Tips & Tricks – All Models

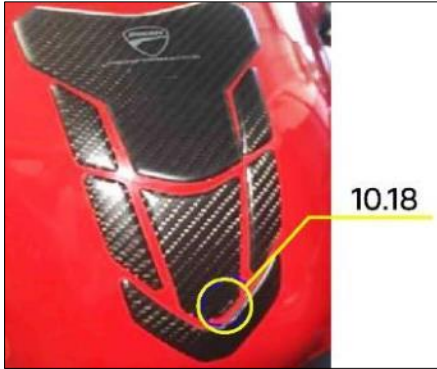
no.	Symptom	Subject	Photo	Notes and Indications - Corrective action
7	<p><u>ONLY</u> <u>models equipped with</u> <u>hydraulically controlled</u> <u>clutch lever</u></p> <p>Possible reduction of the clutch fluid level inside its reservoir</p>	Hydraulic clutch control		<p>We received a few claims concerning a reduction of the clutch fluid level inside its reservoir. We would like to inform you that it is not sufficient to carry out the bleeding procedure or top up the clutch fluid inside the reservoir. We suggest, at a preliminary stage, to check:</p> <ul style="list-style-type: none">• the play between the clutch master cylinder and the lever• if the clutch pushrod is worn or damaged in the area of contact with the clutch slave cylinder (ball)• the condition of the clutch slave cylinder protective diaphragm, which must not be torn. <p>According to our analyses, this phenomenon is due to a DOT4 leakage from the primary seal of the clutch slave cylinder (missing fluid in the reservoir builds up in-between the clutch slave cylinder diaphragms); in some cases, this phenomenon is also accompanied by wear of the clutch pushrod. We therefore ask you to replace the slave cylinder with a new part no. 19540091D featuring a new gasket in order to prevent the phenomenon described above.</p> <p>If the clutch pushrod is damaged as shown in the figure, replace it as well.</p> <div data-bbox="1256 727 1995 1007"></div>

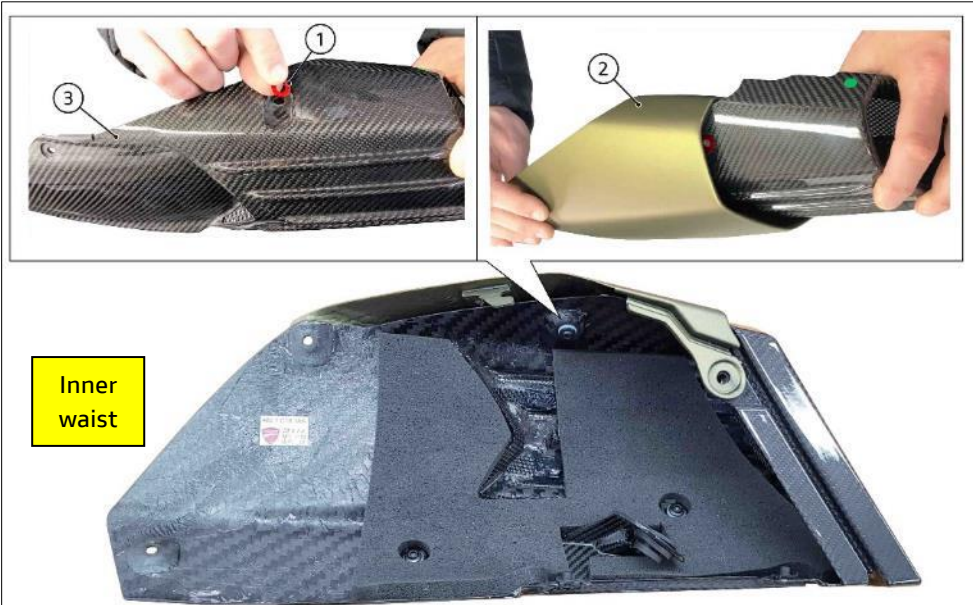
no.	Symptom	Subject	Photo	Notes and Indications - Corrective action																					
13	<p><u>ONLY</u> Streetfighter V4 Panigale V4 Superleggera V4</p> <p>Instrument panel failed switching on upon Key-ON</p>	Instrument panel	-	<p>We received some isolated reports about instrument panel failed switching on; this phenomenon is due to a damage of the instrument panel power supply circuit caused by power disturbance. Should this phenomenon persist, the component must be replaced. The spare instrument panels have been restored thanks to the introduction of a new circuit avoiding the described symptom.</p>

Model	Model Year	Part no.	Streetfighter V4	20	40611781C	Panigale V4 25° Anniversario 916	20	40611351I	Panigale V4	18-19	Panigale V4 S	Panigale V4 S Corse	20	40611351H	Panigale V4	Panigale V4 S	Panigale V4 S Corse	Superleggera V4		
Model	Model Year	Part no.																							
Streetfighter V4	20	40611781C																							
Panigale V4 25° Anniversario 916	20	40611351I																							
Panigale V4	18-19																								
Panigale V4 S																									
Panigale V4 S Corse	20	40611351H																							
Panigale V4																									
Panigale V4 S																									
Panigale V4 S Corse																									
Superleggera V4																									
14	<p><u>ONLY</u> Diavel Model Year 21 XDiavel Model Year 21 Multistrada 1260 Model Year 18-20 Multistrada 1260 Enduro Model Year 19-21 Multistrada 950S Model Year 19-21</p> <p>Possible loss of the active key rear cover</p>	Active key Part no. 59810361F		<p>We have received some isolated reports about the possible loss of the rear cover of the active key Part no. 59810361F. Analyses have shown that this phenomenon occurs after repeated opening/closing of the cover itself, resulting in the deterioration of the shell.</p> <p>We would like to inform you that the new rear cover Part no. 4601L831A, avoiding the phenomenon described above, is now available.</p>

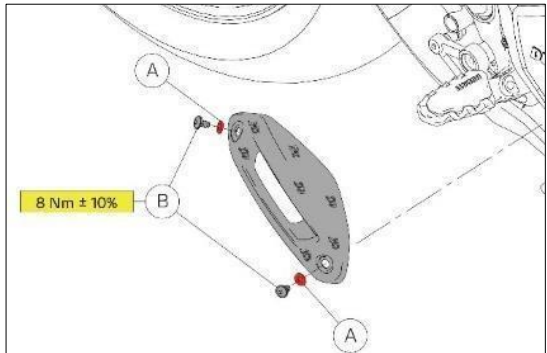
no.	Symptom	Subject	Photo	Notes and Indications - Corrective action
14	<p><u>ONLY</u> <u>Panigale V4 S</u> <u>Streetfighter V4 S</u></p> <p>Possible storage of errors:</p> <ul style="list-style-type: none">- C100C shock absorber rebound - Open circuit- C1009 shock absorber compression - Open circuit	Öhlins monoshock	-	<p>We have received some reports of the following errors being stored:</p> <ul style="list-style-type: none">- C100C: shock absorber rebound - Open circuit;- C1009: shock absorber compression - Open circuit. <p>If any of the above errors are detected, please carry out the following test to confirm the need for replacement of the Öhlins rear monoshock:</p> <ol style="list-style-type: none">1) Swap the connections of the compression and rebound stepper motors;2) Delete any errors stored;3) Perform a Global Scan and determine if a new error code for the rear shock damping is validated4) If it is so, change the rear monoshock.

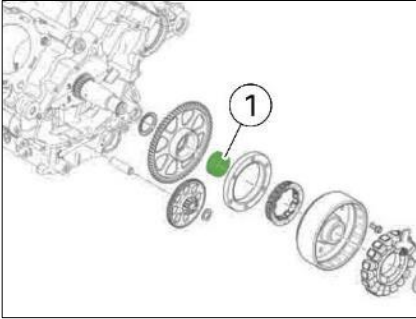
no.	Symptom	Subject	Photo	Notes and Indications - Corrective action
1	<p><u>ONLY Panigale V2</u></p> <p>Precautions during PDI: installation of the side half-fairings</p>	Side half fairings		<p>We received some isolated claims about the possible breakage of the top fastener retaining the LH side half-fairing to the headlight fairing.</p> <p>During PDI and whenever removing the side half-fairings, we remind you to pay utmost attention to the tightening of the 2 screws M5x0.8 (1) retaining the upper LH and RH half-fairings to the headlight fairing; always comply with the specified tightening torque of 2 Nm ± 10%.</p> 
2	<p><u>ONLY Panigale V4</u></p> <p>Precautions during PDI: installation of the balancing weights on the handlebar</p>	Handlebar counterweights		<p>We received some isolated claims about the possible triggering of a longitudinal crack on the handlebar, on balancing weight side. Our laboratory analyses found that said crack is due to an excessive tightening torque applied when installing the balancing weights.</p> <p>When installing balancing weights on the handlebar, please comply with the tightening torque specified for the M6x55 screw of 8 Nm ± 10%, as indicated on the bulletin introducing the model and on the Workshop Manual.</p>

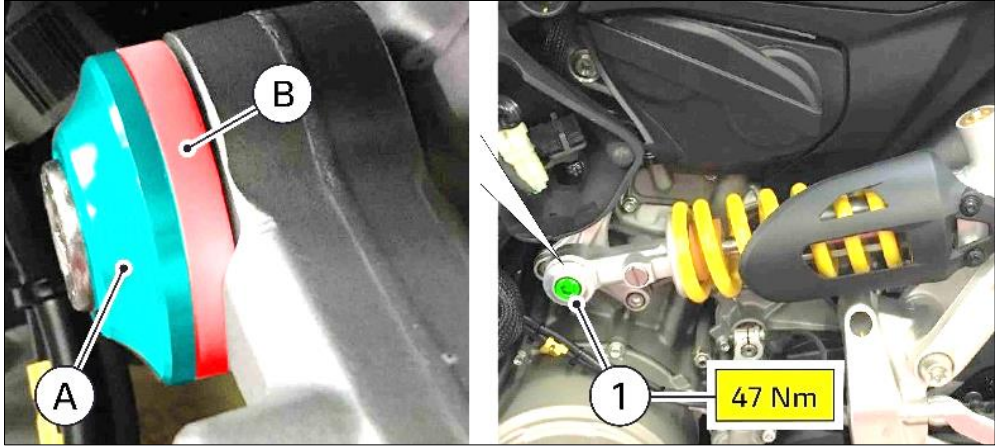
no.	Symptom	Subject	Photo	Notes and Indications - Corrective action
11	<p style="text-align: center;"><u>ONLY</u> 959 Panigale (all versions)</p> <p>Possible hardening of gear shift control with difficulty in shifting gears when hot</p>	Gear selector	-	<p>We have received some isolated reports about a possible hardening of the gear shift when hot with consequent difficult selection of gear ratios. Based on the analyses carried out, this phenomenon could be due to a hardening between the gearbox sensor magnet plastic support and the relevant seat inside the cover.</p> <p>You are kindly asked to carry out the following operations:</p> <ol style="list-style-type: none"> 1) Remove the gear shift cover (1) on motorcycle LH side; 2) Check for the presence of shim (2); 3) Mill the end face of the plastic cage for the selector magnet (3) shorter by 0.1 mm maximum and the outer curved edge where it enters the bore of the cover by 0.1 mm maximum, <u>or</u> mill the internal surface (4) of the cover highlighted in the figure and remove 0.1 mm maximum of material from the end and bore of the recess. Ensure the orientation of the magnet is not changed on the shift selector or the gear position will not be able to be determined by the sensor. <div style="display: flex; justify-content: space-around; margin-top: 10px;">    </div>

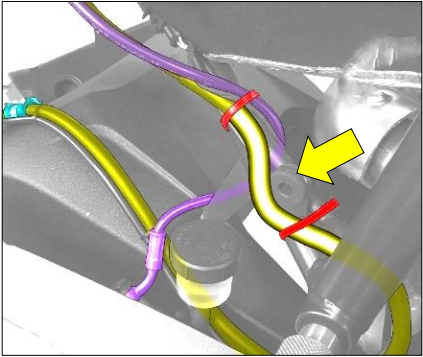
no.	Symptom	Subject	Photo	Notes and Indications - Corrective action	
17	<p><u>ONLY</u> Panigale V4R</p> <p>Introduction of clutch housing with deep anodizing</p>	Clutch housing		<p>We have received some isolated reports of possible clutch slipping, due to clutch housing indentation, which does not allow the drive and driven plates to come back into contact with each other correctly. This phenomenon depends on the use of the motorcycle and the user, therefore for racing use we suggest replacing the plates approximately every 5000km,.</p> <p>We would like to inform you that the new clutch housing with deep anodizing part no. 19810671C, replacing the natural grey one, is available as a spare part; this treatment improves the reliability of the clutch housing reducing the damaging of the drive plates on its contact surface.</p>	
<p>NEW</p> <p>18</p>	<p><u>ONLY</u> Panigale V4 MY21</p> <p>Error "P0919 - Gear sensor plausibility" with MIL warning light turning on and/or failed display of the engaged gear on the instrument panel</p>	Error "P0919 - Gear sensor plausibility"	-	<p>If the error "P0919 - Gear sensor plausibility" occurs, <u>do NOT replace the gear sensor.</u></p> <p>It is necessary to check that the engine control unit software version is updated, then access the "Settings" section and activate the "<u>Reset of the final drive adaptive parameters</u>".</p> <div data-bbox="1765 676 2213 1062" style="border: 1px solid black; background-color: #ffff00; padding: 5px;"> <ul style="list-style-type: none"> CCP Enabling/Disabling DQS adaptives reset Idle control adaptives reset Idle speed engine operation mode Knock sensor adaptives reset Reset gears <li style="border: 2px solid red; background-color: #ffff00;">Reset of the transmission adaptive values </div>

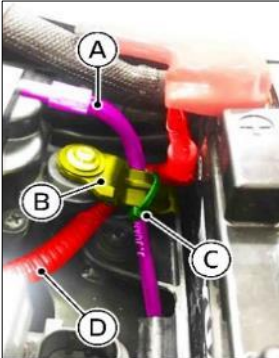
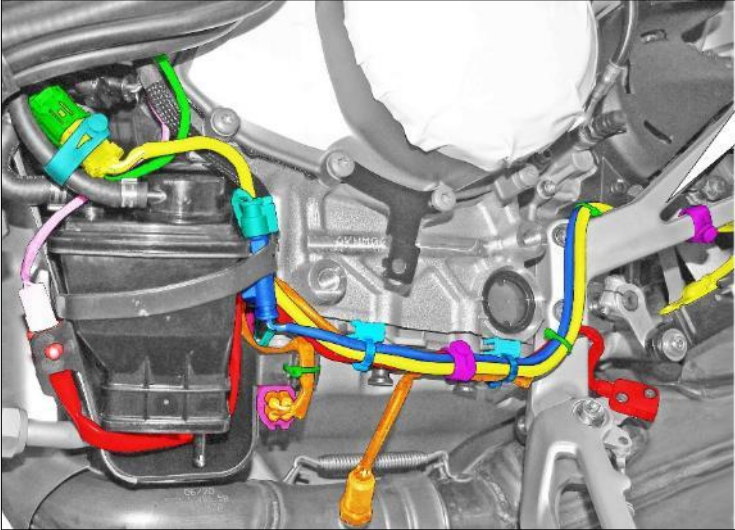
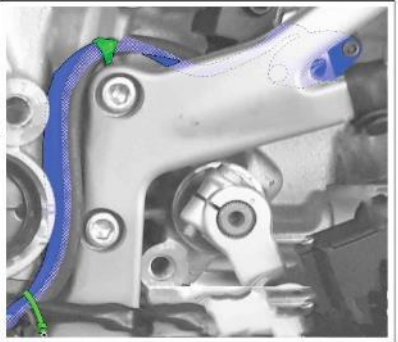
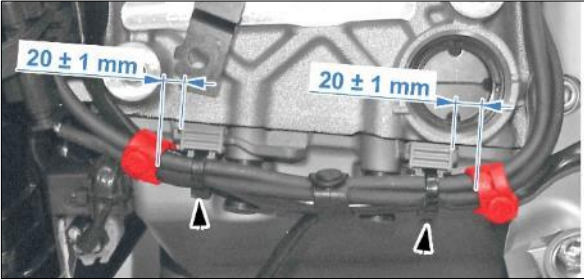
no.	Symptom	Subject	Photo	Notes and Indications - Corrective action				
1	<p><u>ONLY Scrambler 800 (all model versions and MY, excluding Desert Sled model version)</u></p> <p>Precautions when routing the rear brake caliper hose</p>	Rear brake hose	-	<p>We have found that sometimes, during maintenance operations, the rear brake caliper hose is not correctly positioned along the frame due to incorrect installation by the technician during service.</p> <p>Make sure that the rear brake caliper hose (yellow), passes outside the left side cover mounting bracket with respect to the motorcycle centerline and is fixed with the two self-locking ties (red) as shown in the figure.</p> <p>The operation of inspection and possible repositioning is very simple and involves the disassembly of the left side cover only.</p> 				
2	<p><u>ONLY Scrambler 1100 (all model versions)</u></p> <p>Assembly precautions for Bracket accessory kit for side panniers part no. 96781361A</p>	Bracket accessory kit for side panniers part no. 96781361A		<p>Due to a supply error, you may find brackets for soft side bags inside the accessory kit and the presence of a pair of non-compliant M10X45 screws as they are partially threaded instead of completely threaded, as shown in the figure.</p> <p>We ask you to always check that all the kit components are present and correct before installing them and, if the screws are not correct, order the 2 screws M10X45 part no. 77242713C (the parts in stock have been reclaimed).</p> <table border="1" data-bbox="1167 895 2051 1098"> <thead> <tr> <th data-bbox="1167 895 1608 935">NON-COMPLIANT Screw M10X45</th> <th data-bbox="1608 895 2051 935">COMPLIANT Screw M10X45</th> </tr> </thead> <tbody> <tr> <td data-bbox="1167 935 1608 1098">  </td> <td data-bbox="1608 935 2051 1098">  </td> </tr> </tbody> </table> <p>We would also like to inform you that there is a label on the kit box, and at the top right it bears numbers indicating the progressive number and the year of manufacture. The kits that may include the 2 non-compliant M10X45 screws and therefore need to be inspected before proceeding with the installation are numbers "19053" and "19064".</p> 	NON-COMPLIANT Screw M10X45	COMPLIANT Screw M10X45		
NON-COMPLIANT Screw M10X45	COMPLIANT Screw M10X45

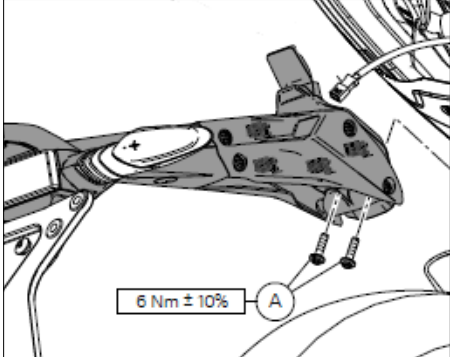
no.	Symptom	Subject	Photo	Notes and Indications - Corrective action
4	Assembly precautions Anti-theft system kit part no. 96680811A	Anti-theft system kit Part no. 96680811A		Please, be reminded that if anti-theft system kit Part no. 96680811A is installed for model Streetfighter V4, the anti-theft system/DMS support set (additional wiring with anti-theft system fastening support bracket) Part no. 96680941BA must be purchased at the same time, as specified on the spare part catalogue "compatibility" section.
5	Possible flashing of low fuel light	Low fuel warning light	-	<p>We have received some isolated claims about the flashing of low fuel light; this phenomenon is due to an electric problem of the thermistor resulting in the validation of Error P0460 - Fuel level sensor [Short circuit to positive or Open circuit].</p> <p>Please, fill in a Youtech service request and then replace the component by ordering a new spare one Part no.69928751A.</p>
